Final Set, Jefferson Village Phase II  
(Bulletin 6)

JEFFERSON VILLAGE

TYPICAL PAVEMENT CROSS SECTIONS

HOR. SCALE: NO SCALE  
VER. SCALE: NO SCALE  
DATE: 3-27-00  
JOB NO.: DE99011  
FILE NO.: DE9911X1  
SHEET NO.: P-0.2

JEFFERSON VILLAGE  
INTERSECTION DETAILS  
MEADOWBROOK AVE.

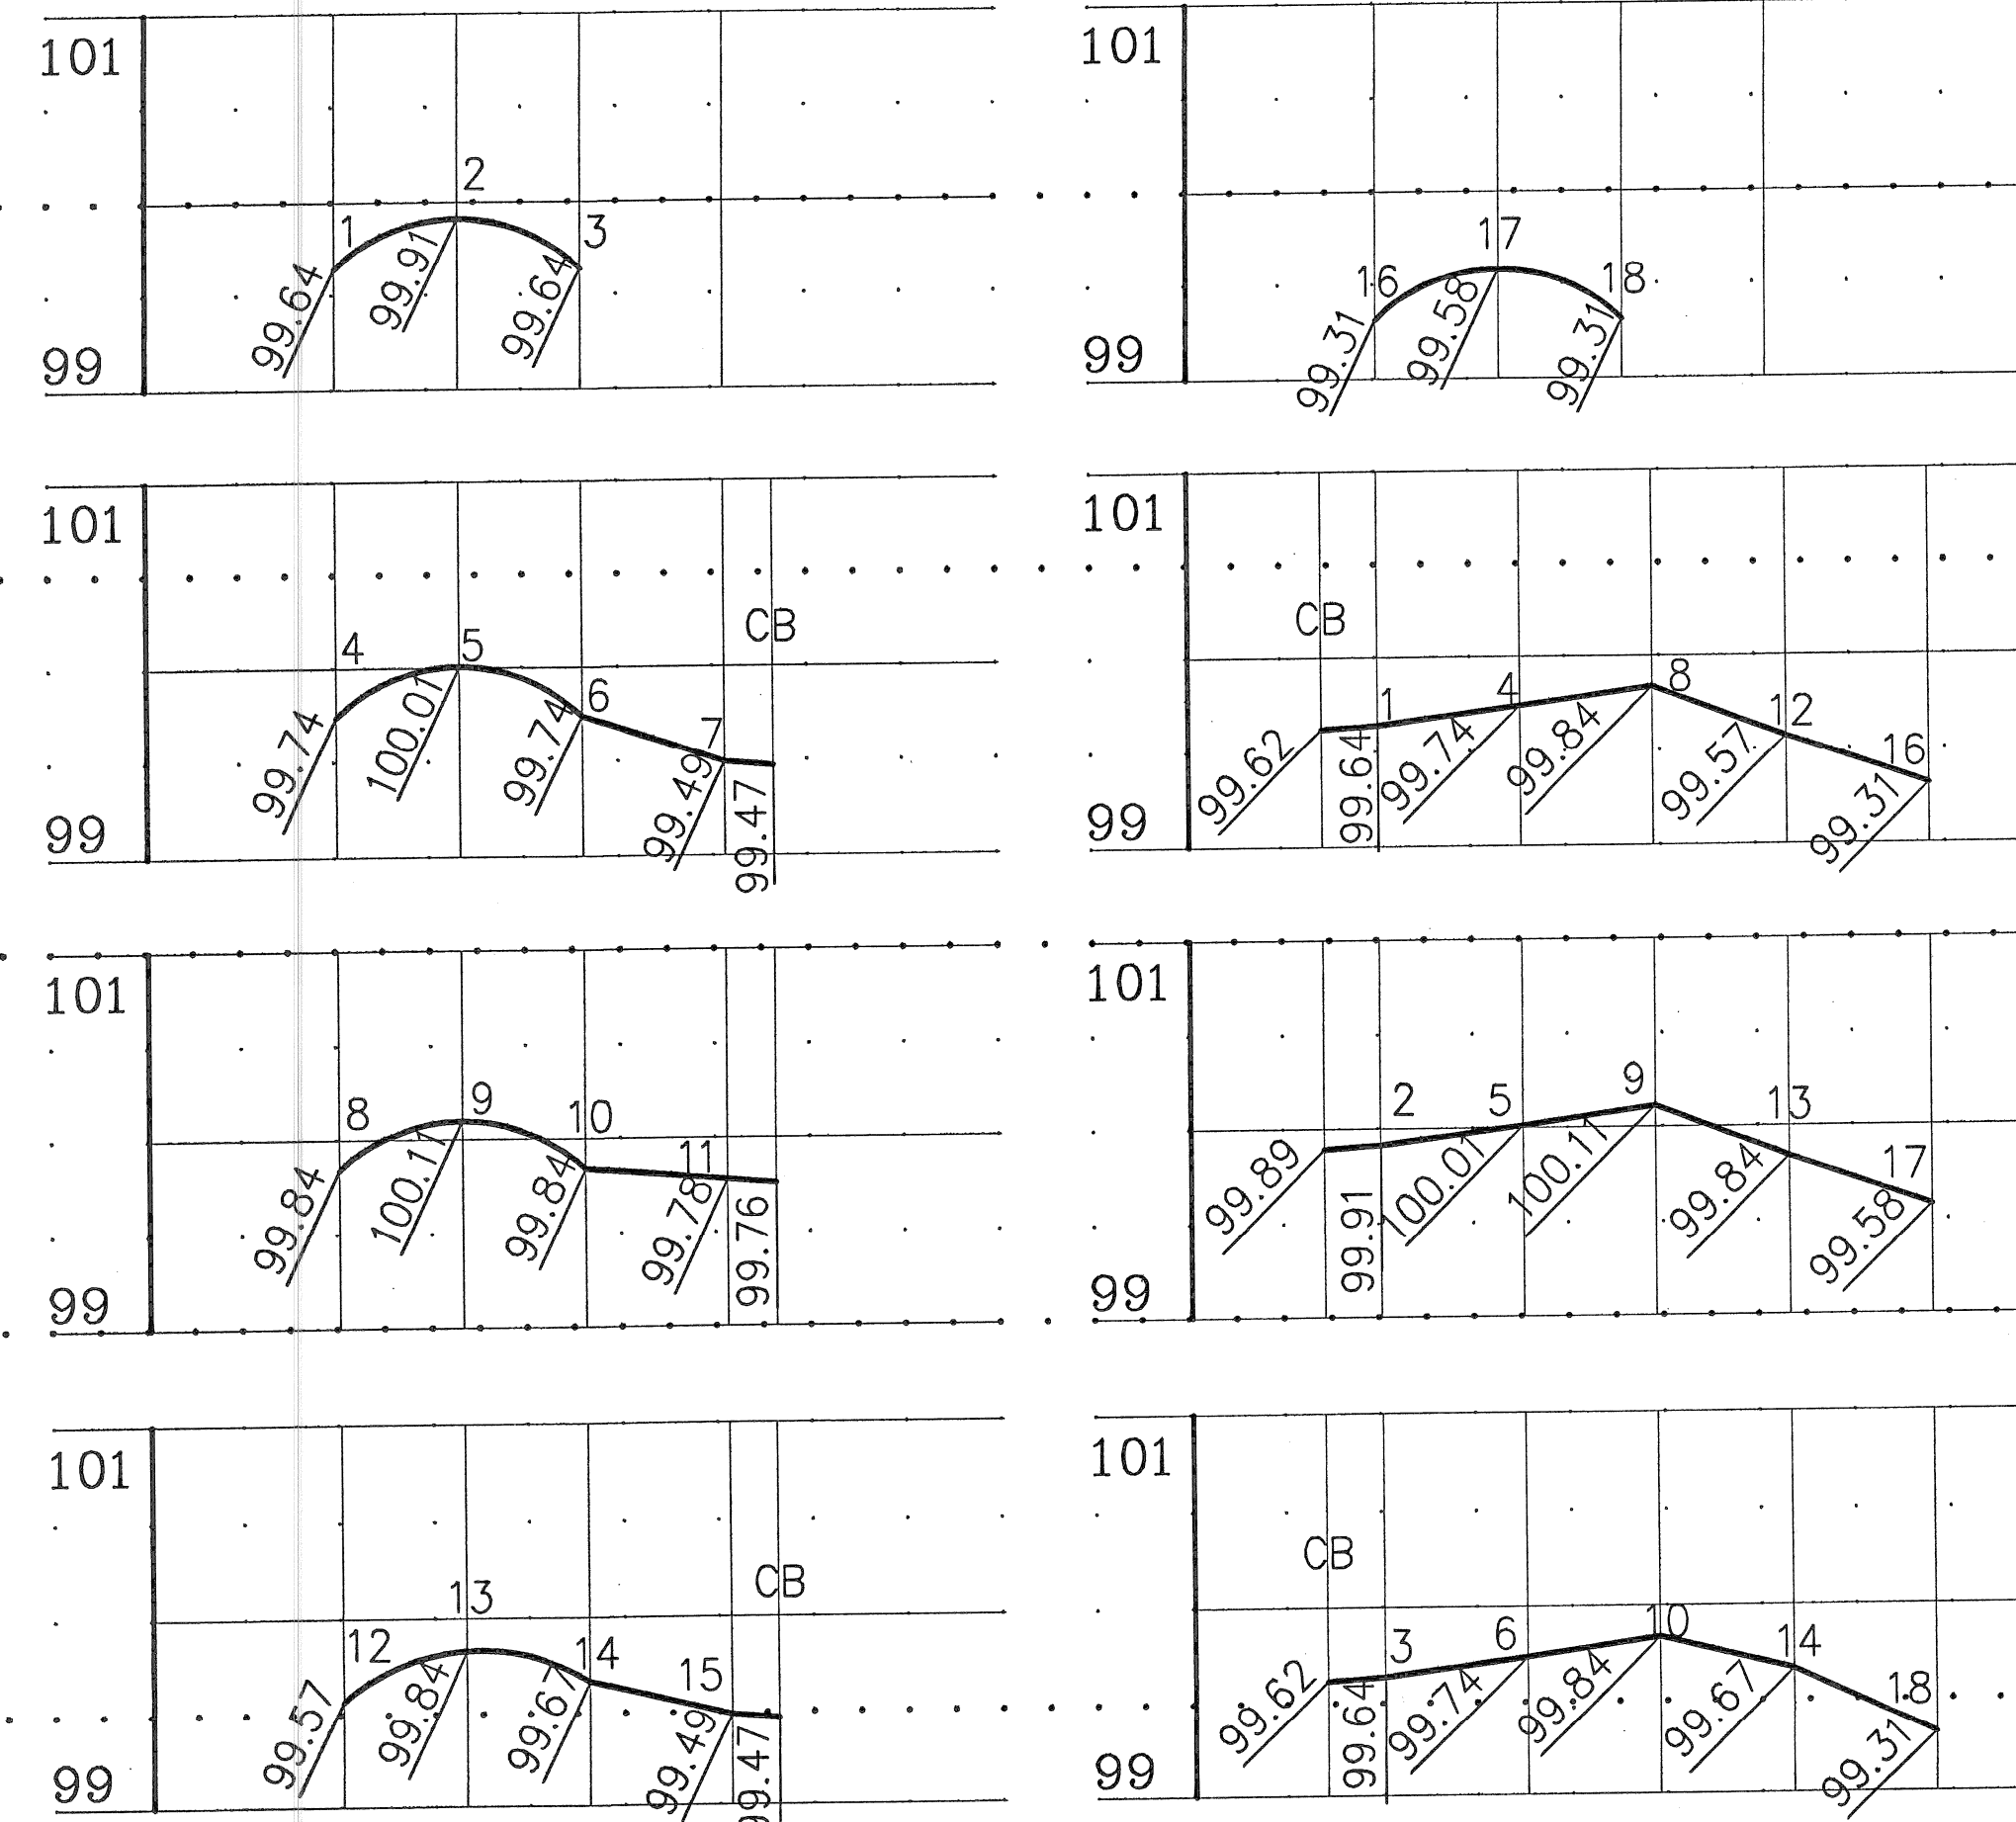
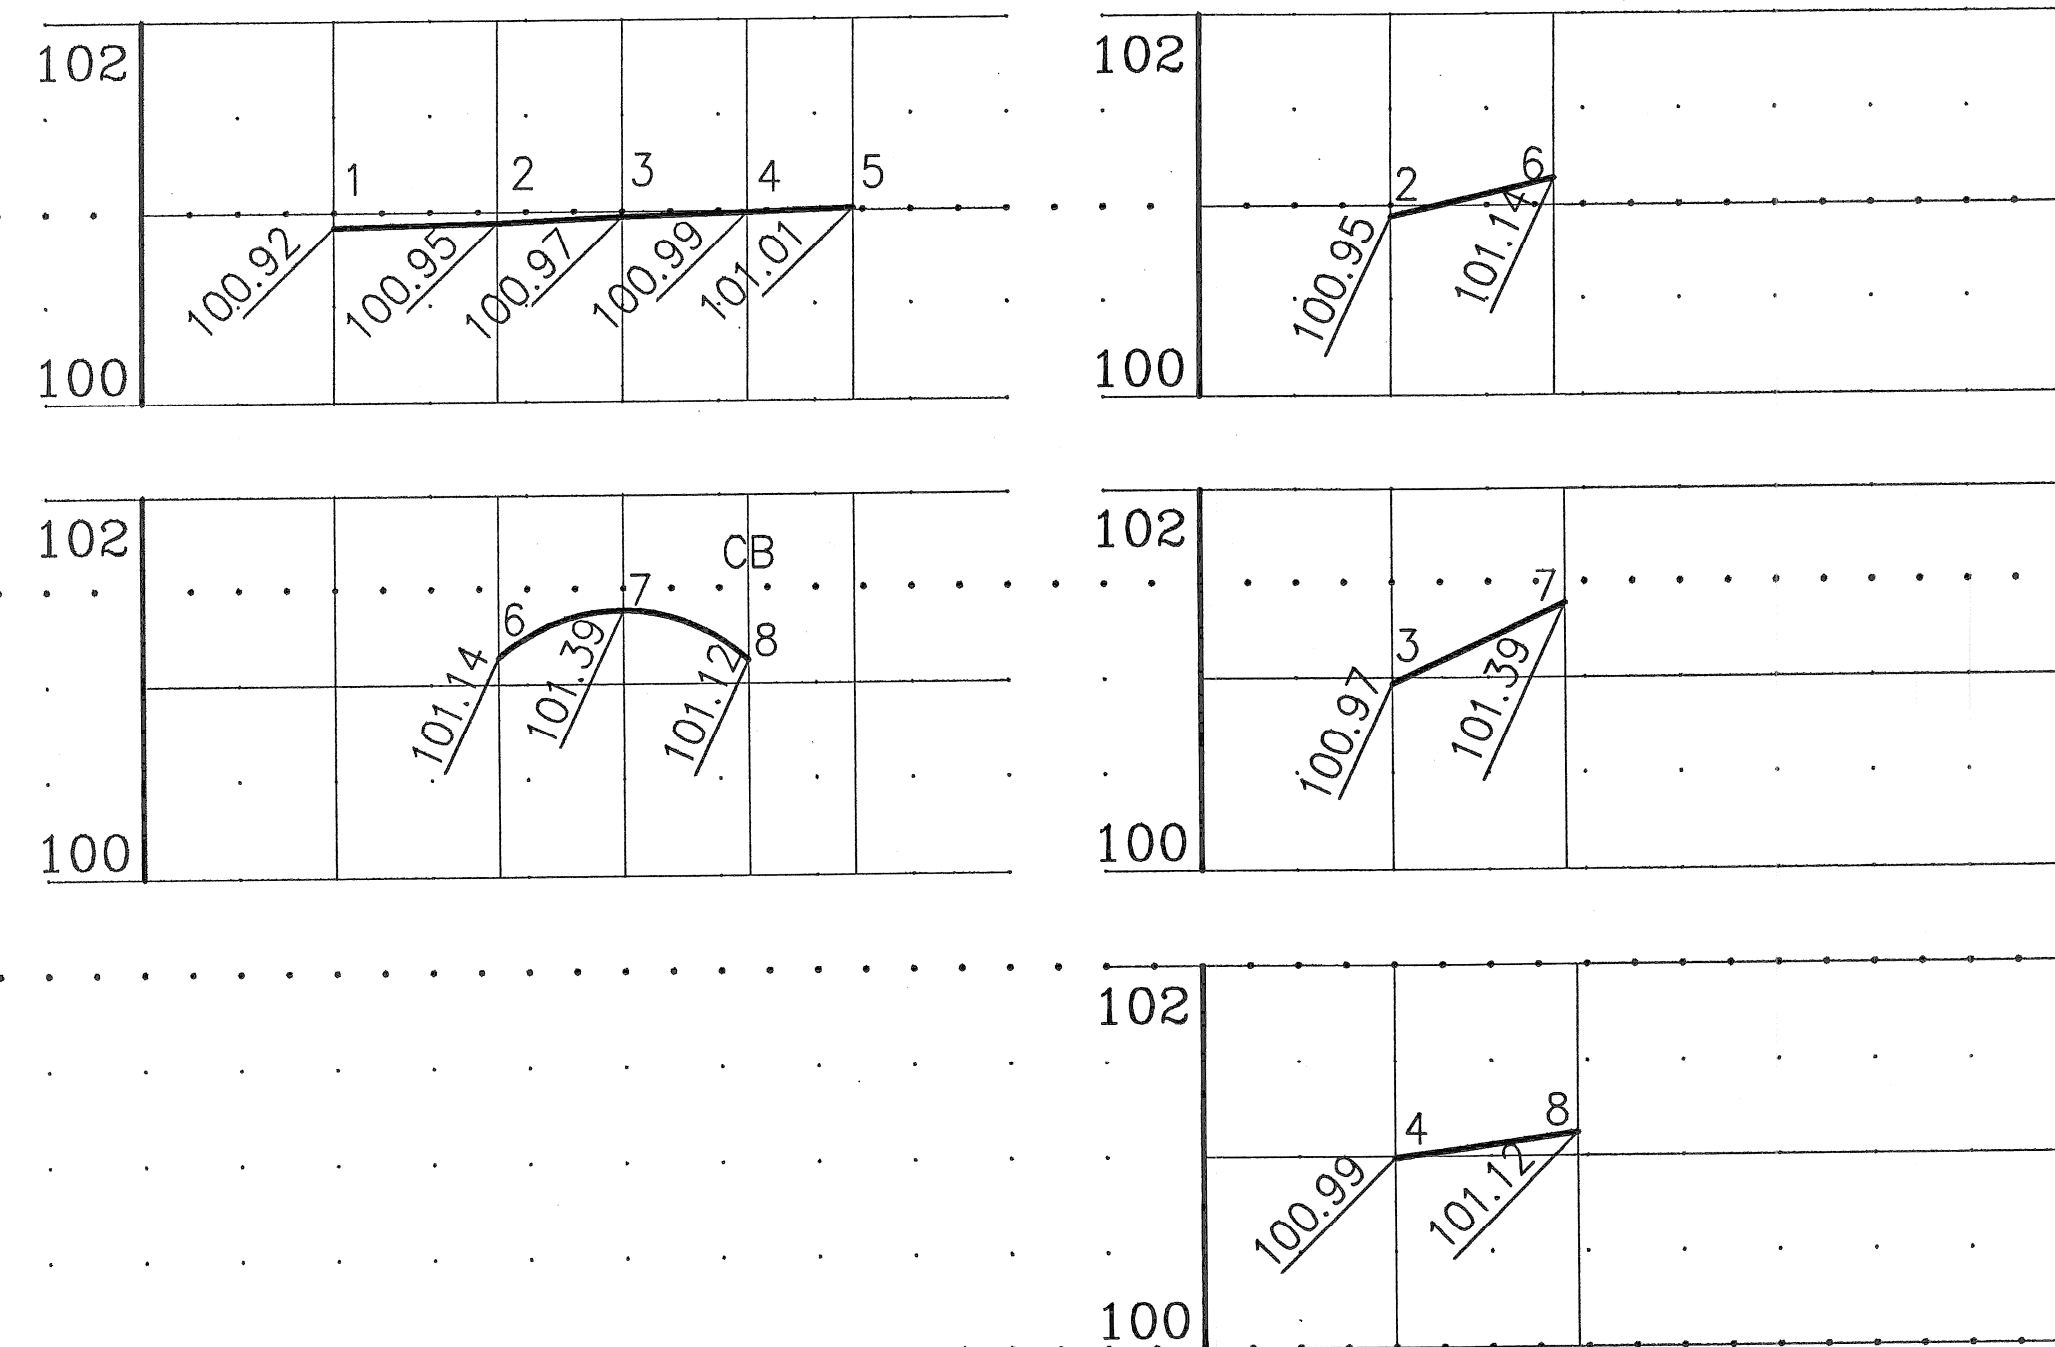
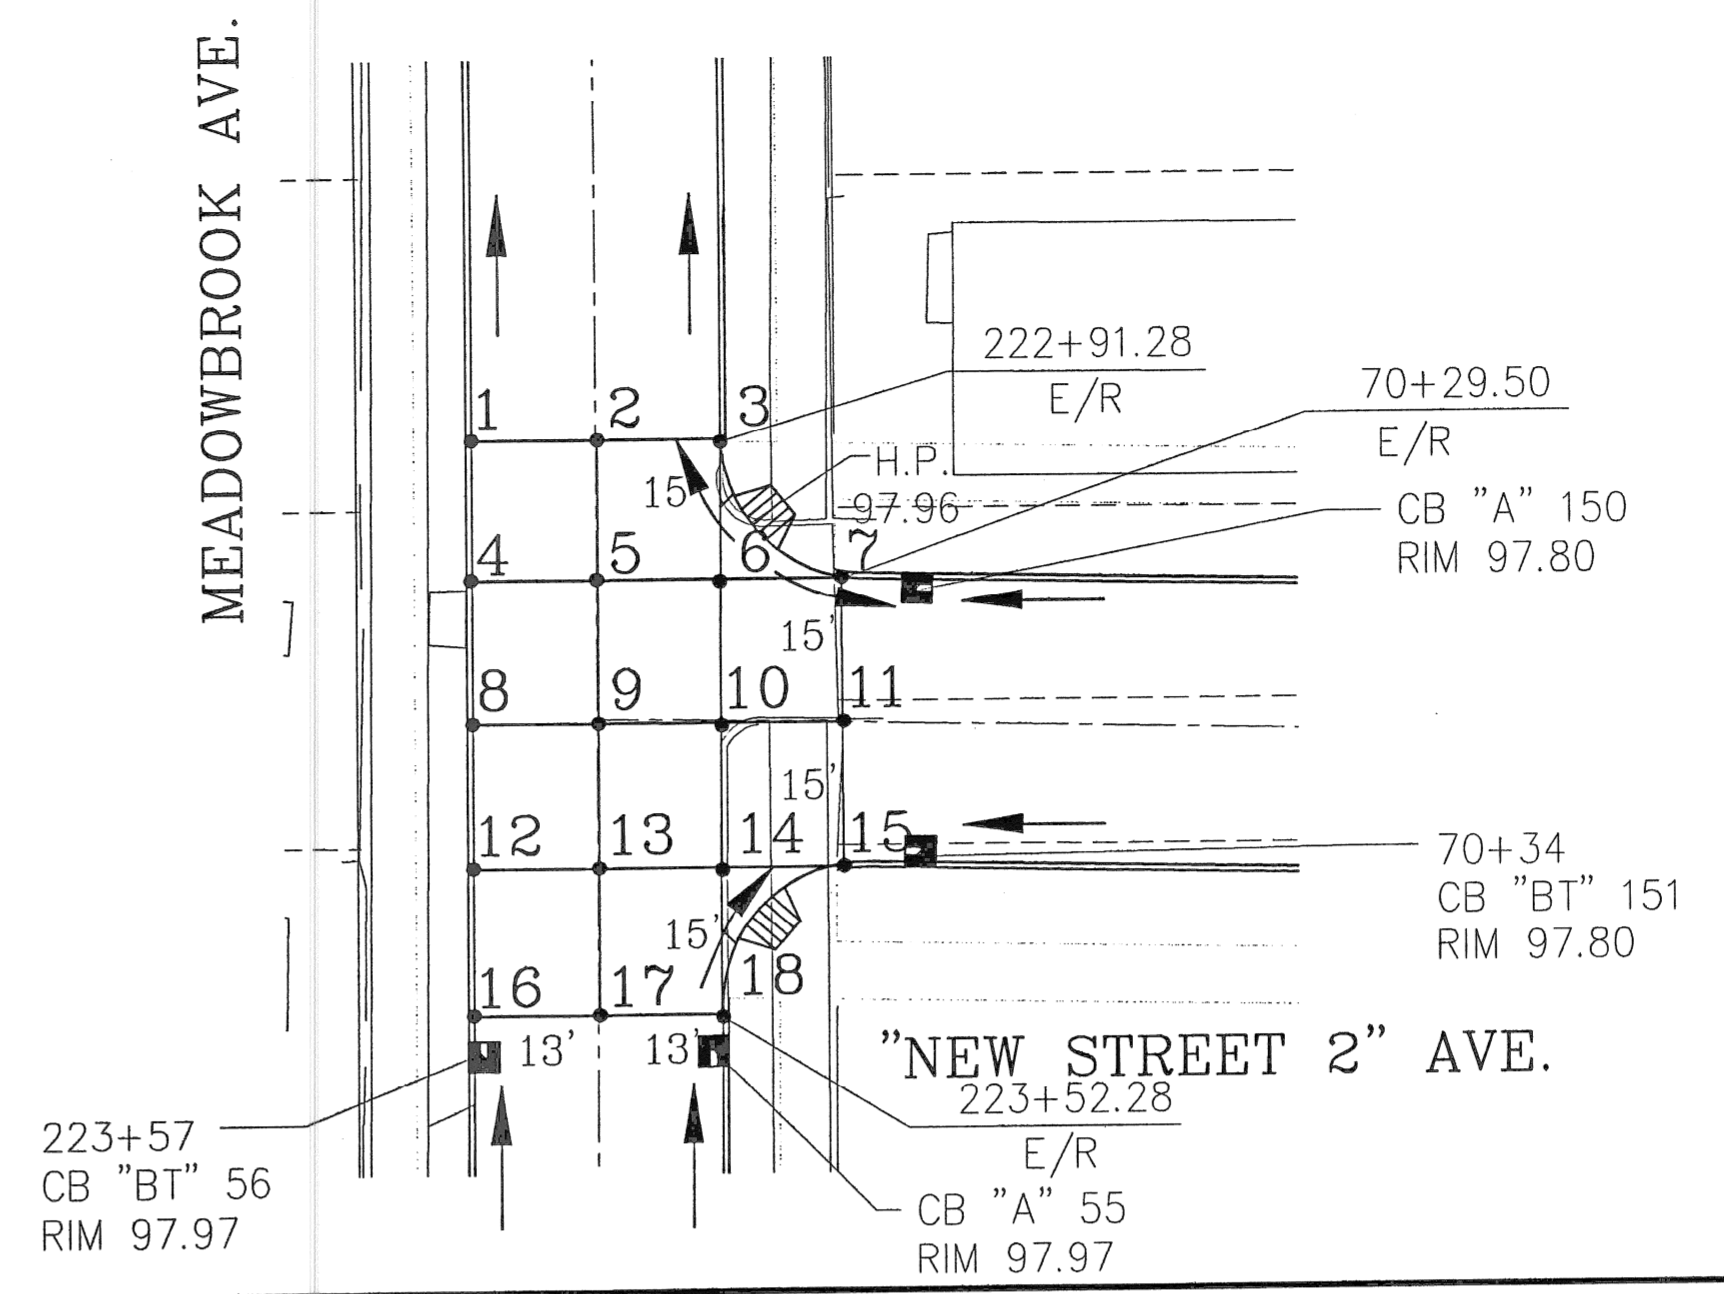
**NOTE:**  
WHERE PROPOSED ROLL CURB TIES INTO EXISTING CURB/7" HIGH CURB THE CONTRACTOR SHALL TAPER DIMENSIONS OF THE PROPOSED CURB OVER A LENGTH OF FIVE (5') FEET TO MATCH THE EXISTING/7" HIGH TOP OF CURB, FACE OF CURB AND BACK OF CURB. PAYMENT FOR THIS WORK SHALL BE CONSIDERED AS BEING INCLUDED IN THE COST FOR ALL OTHER CONCRETE PAVEMENT WORK.
